Docket Item # 3 & 4
BAR CASE # 2012-0401 &
2012-0402

BAR Meeting
January 16, 2013

ISSUE: Partial Demolition/Capsulation, Addition and Waiver of Rooftop HVAC Screening Requirement

LOCATION: 323 Duke Street

DEMOLITION & ENCAPSULATION

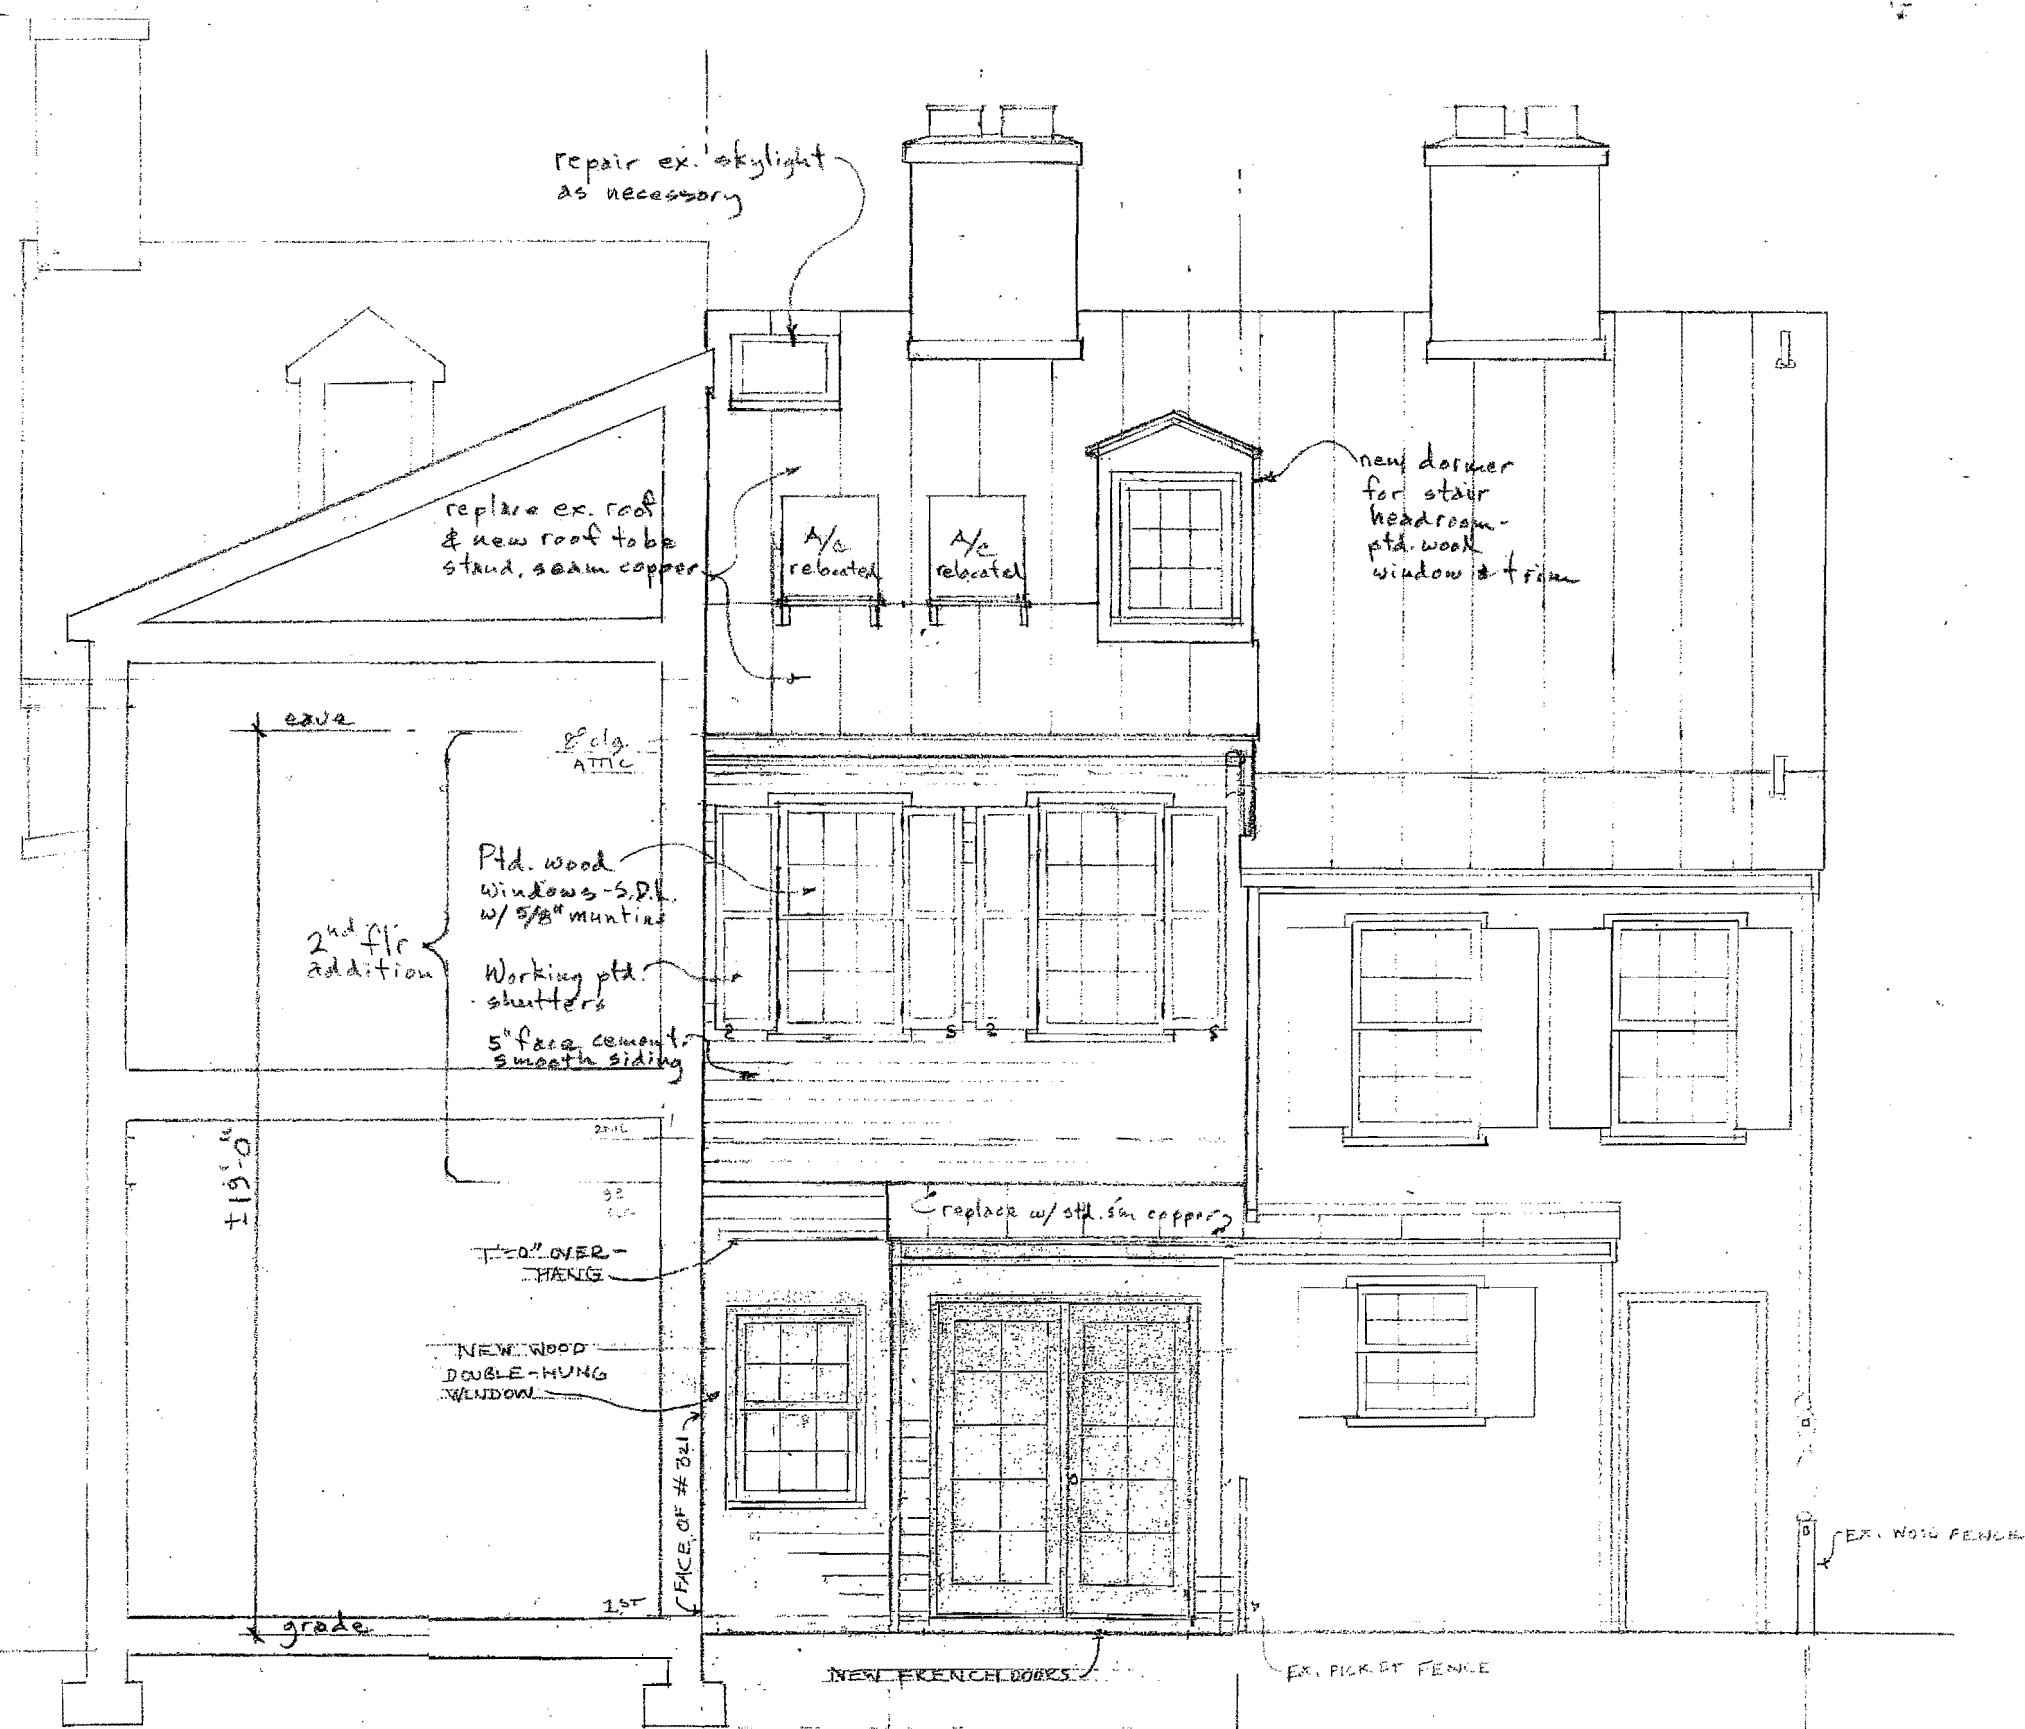
1. That the two historic windows on the rear (north) elevation be salvaged and reused on site, either in the new addition or for materials for necessary repairs for front windows.

In the opinion of Staff, the criteria to demolish and capsule generally are not met and the Permit to Demolish should be granted. The area proposed for demolition, most of the rear (north) elevation, has been altered significantly and does not appear to have much remaining 19th-century historic material, with the exception of two six-over-six wood windows at the second story, which appear to be quite early if not original. The proposed demolition is typical of the amount of demolition/capsulation that the Board regularly approves. The area of demolition for the proposed dormer is also minimal in scope. Staff does not believe that the proposed demolition will compromise the overall integrity of the townhouse though recommends that the two historic windows be salvaged and reused on site.

NORTH ELEVATION

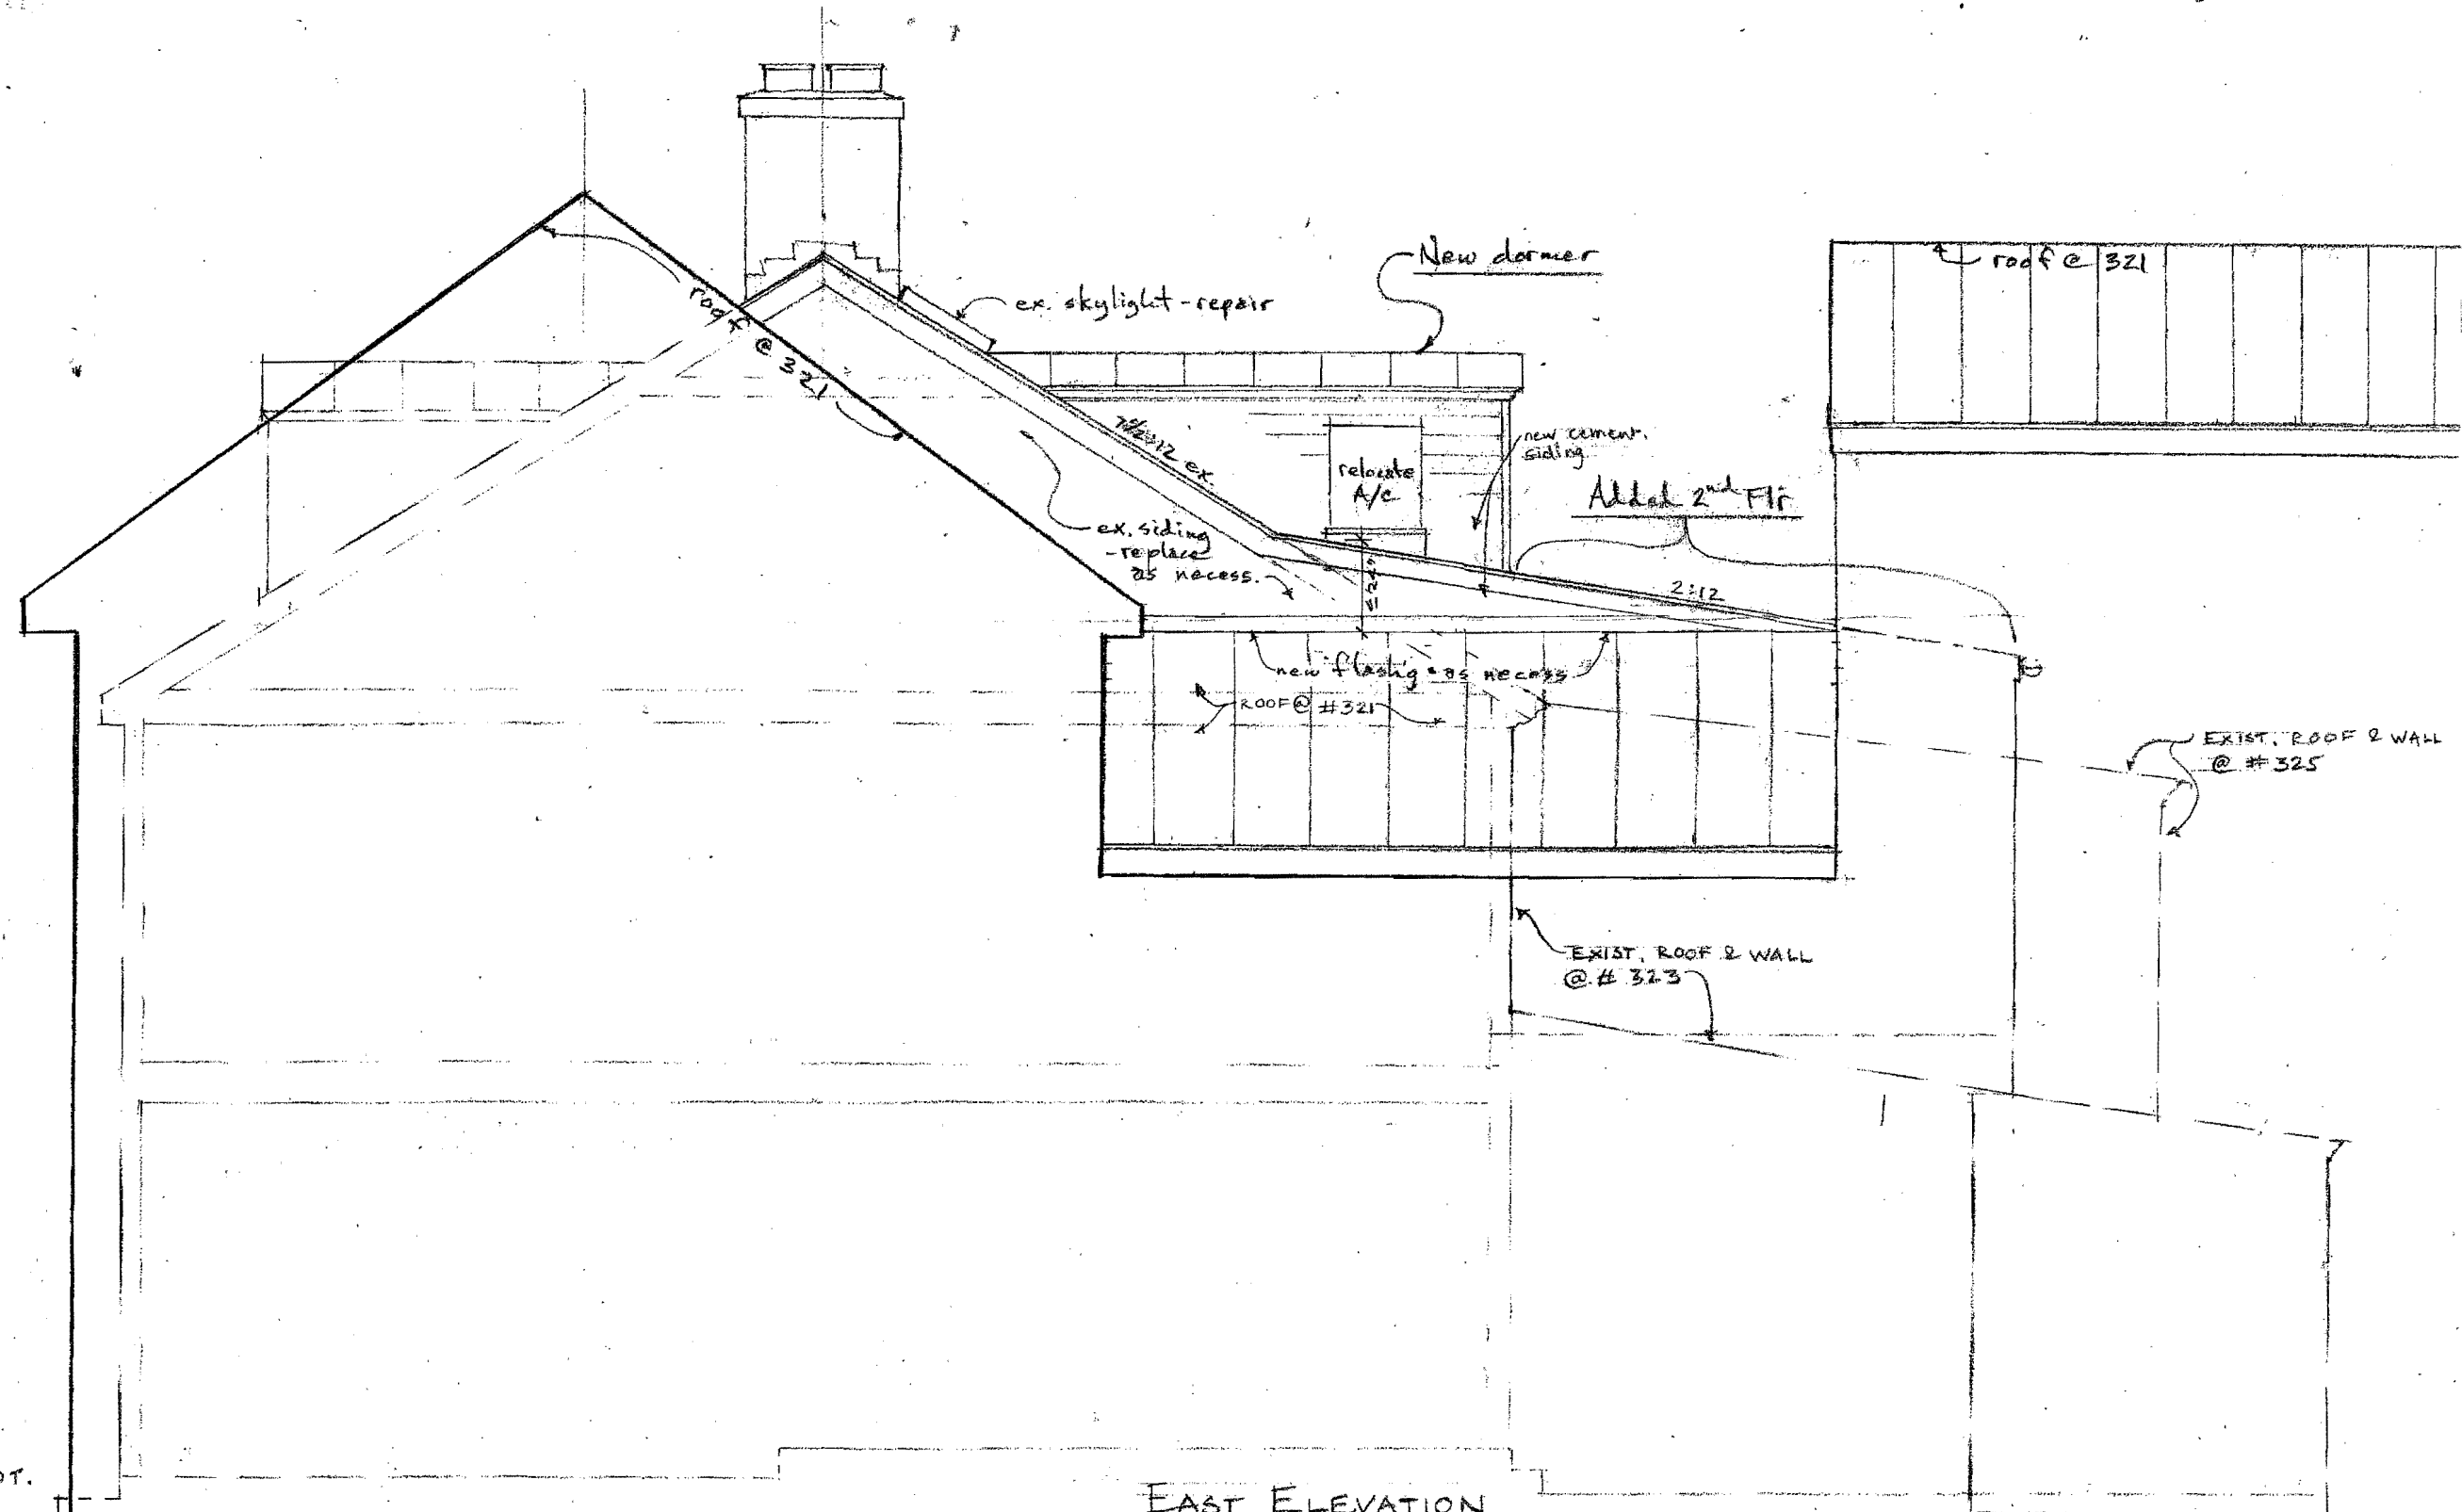
Although the previously proposed addition did not represent a large floor area or ceiling height, it nevertheless disrupted the existing roof form and overwhelmed the adjacent structure. Staff strongly encouraged the applicant to restudy, which they have now done with the current proposal of a two-story rear addition and single dormer.

The *Design Guidelines* encourage designs for new additions that are “respectful of the existing structure and which seek to be background statements or which echo the design elements of the existing structure.” Staff finds that the proposed very simple, two-story shed roof addition complements the existing historic building as it reconstructs the existing massing and scale of the addition to be demolished. The proposed dormer is appropriately scaled and well-detailed. The offset location of the dormer echoes that of the front dormer and also partially screens the proposed rooftop HVAC units. While Staff would prefer that the HVAC units remain on the ground, Staff believes that they will be partially screened by the new rear dormer and will not
